Site Instruction

SI 23

PROJECT : Hampton Manor
PROJECT No : 1136.13
DATE : July 25, 2018

Title: Mechanical Double Door Entry.

MECHANICAL FLOOR PLAN

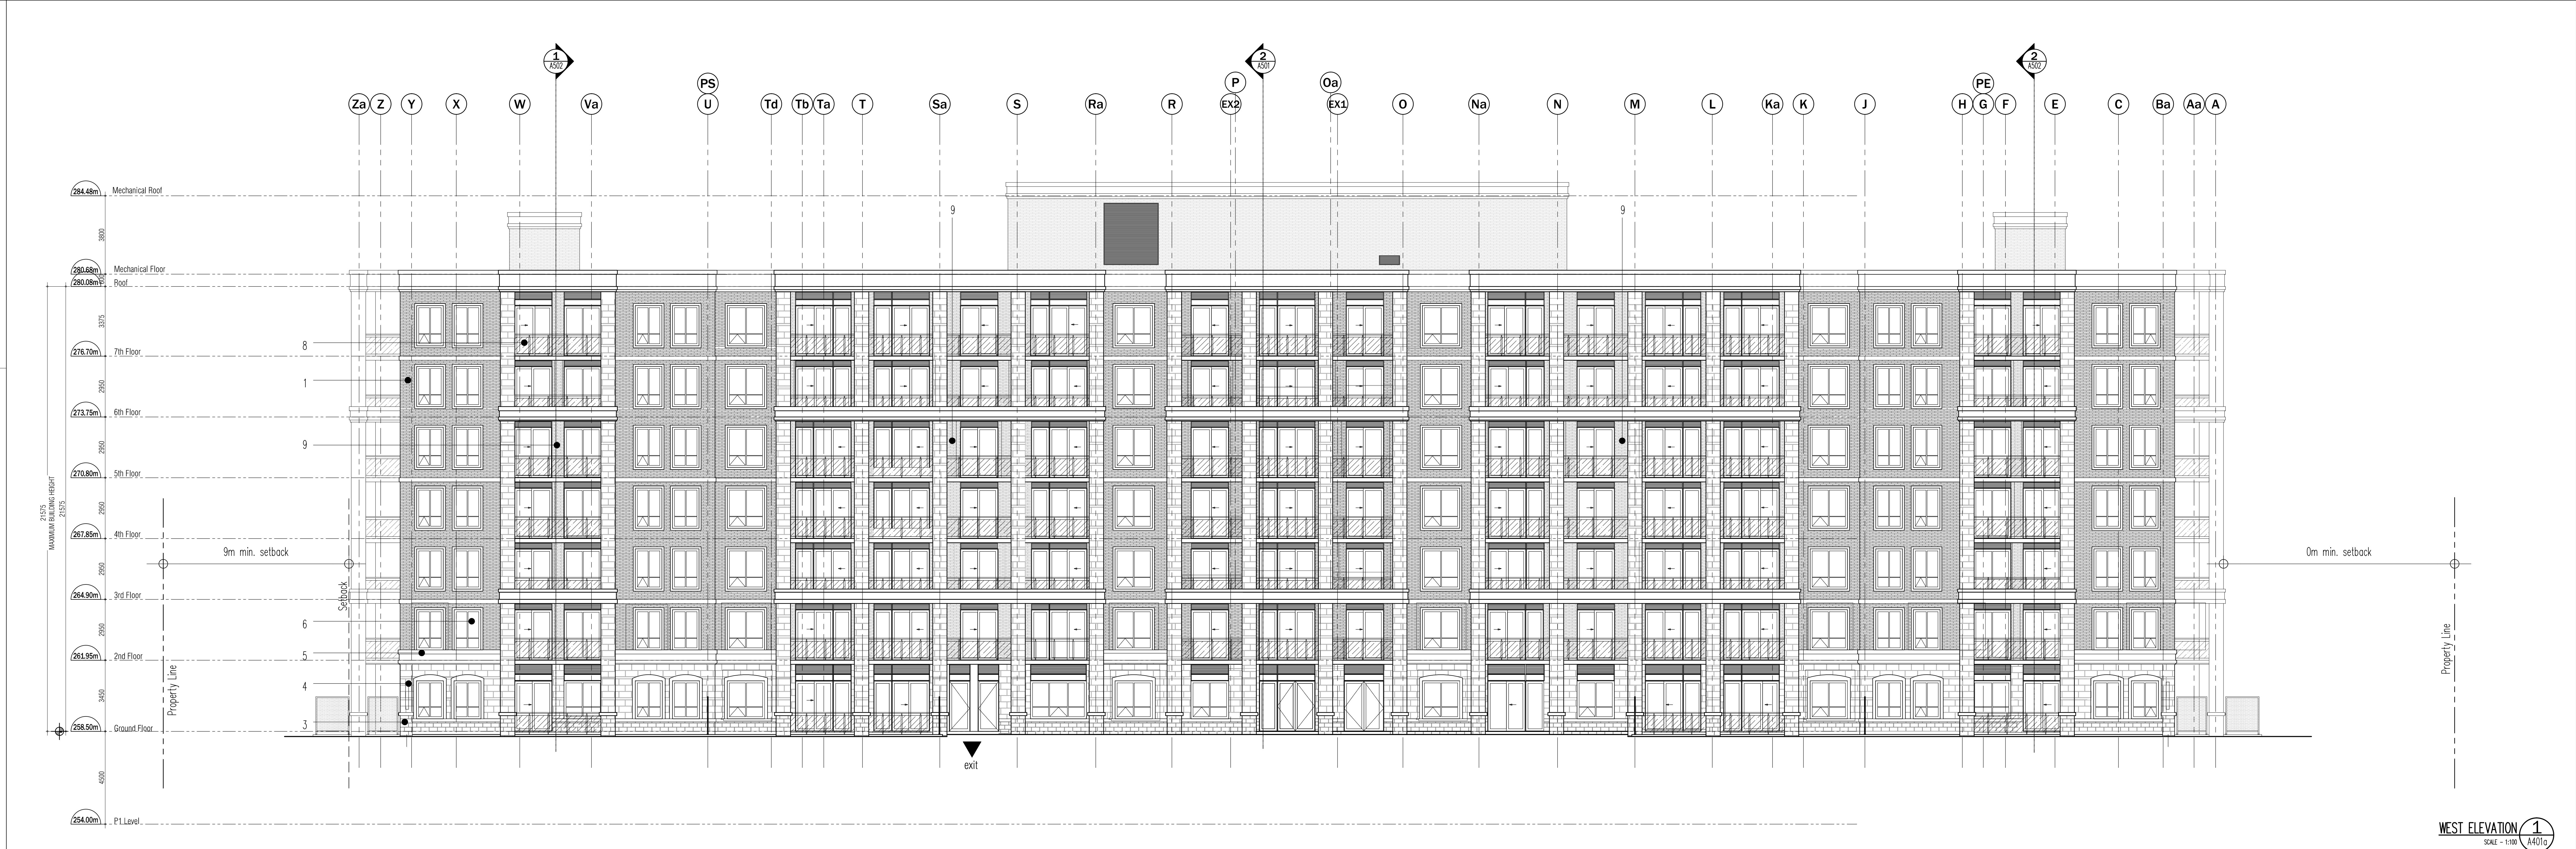
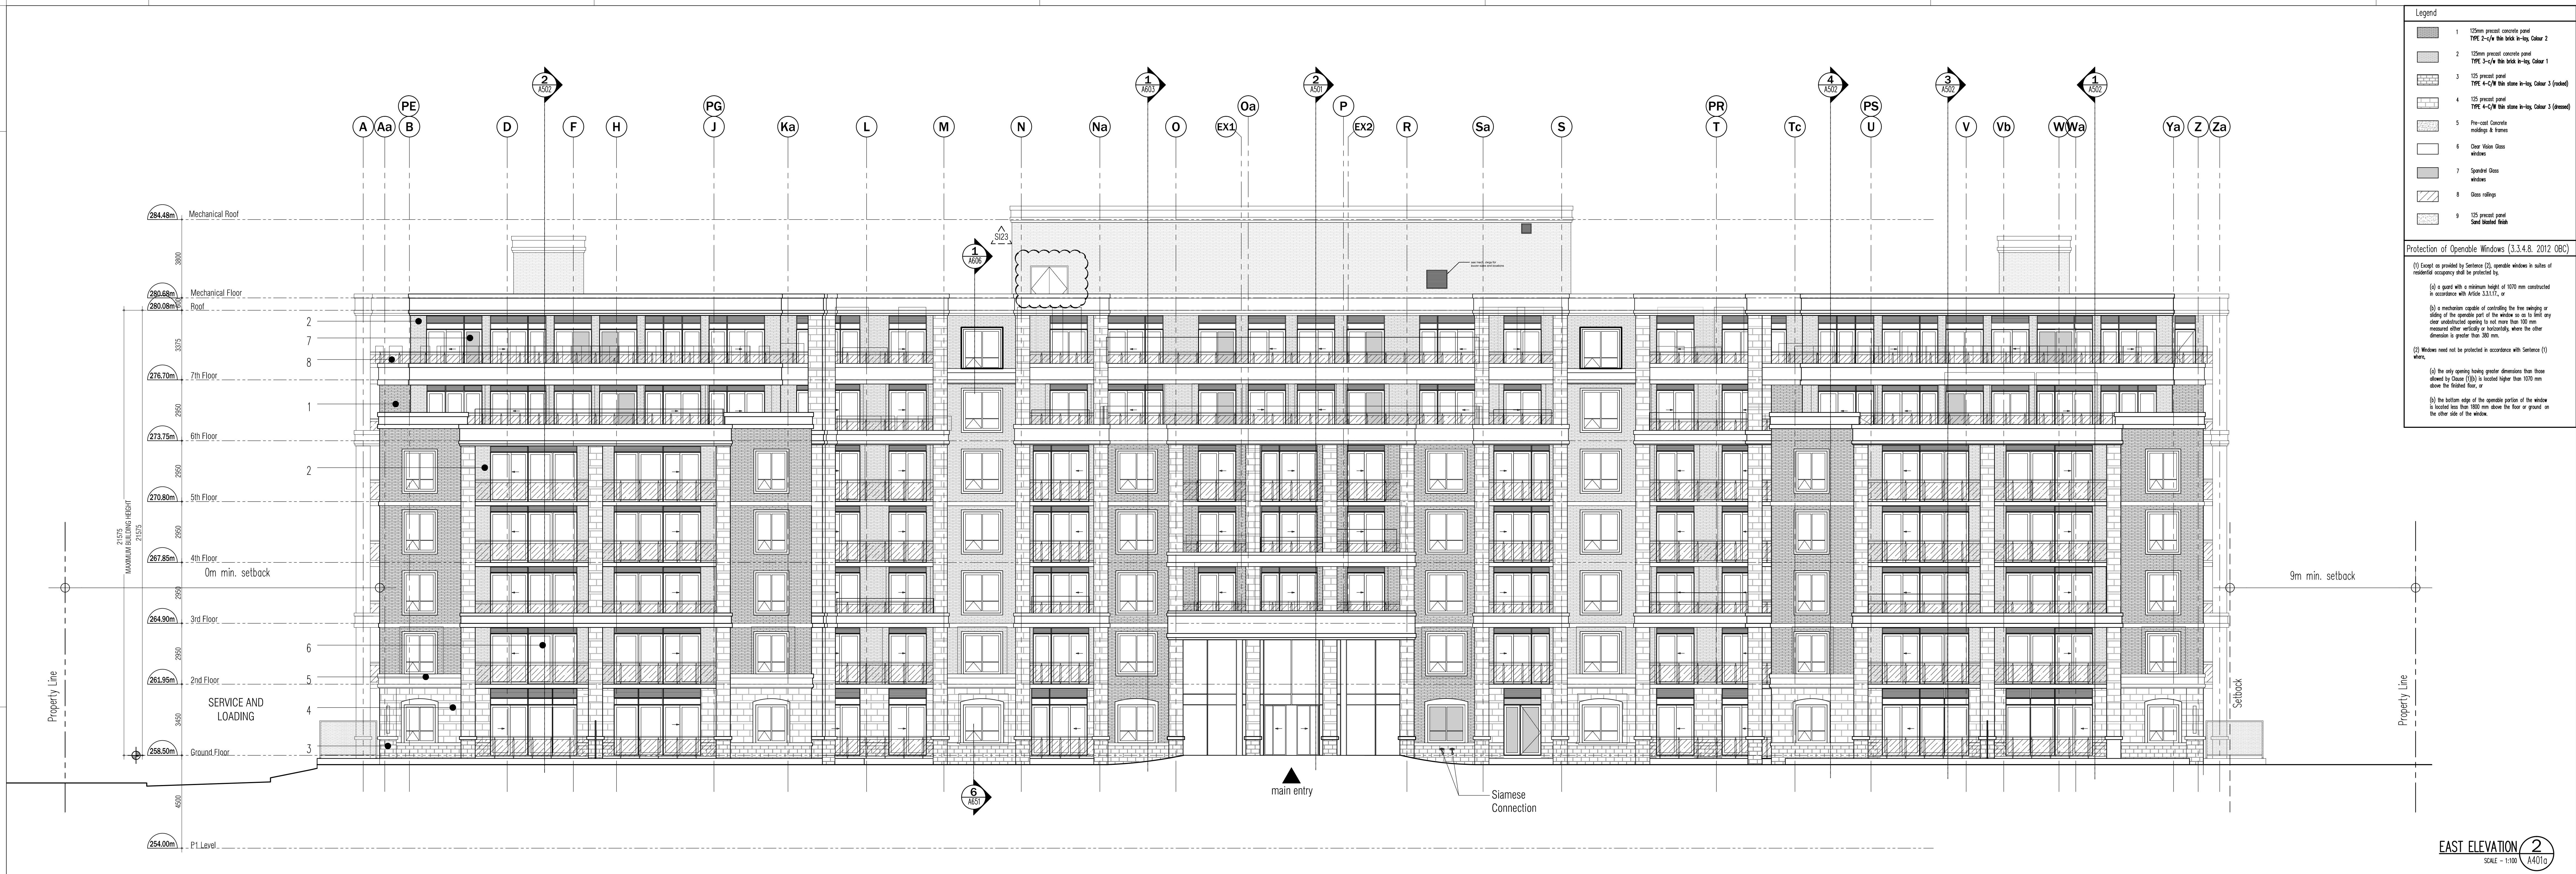
- Double door added to east elevation of mechanical penthouse with intake louvre relocated to south elevation.
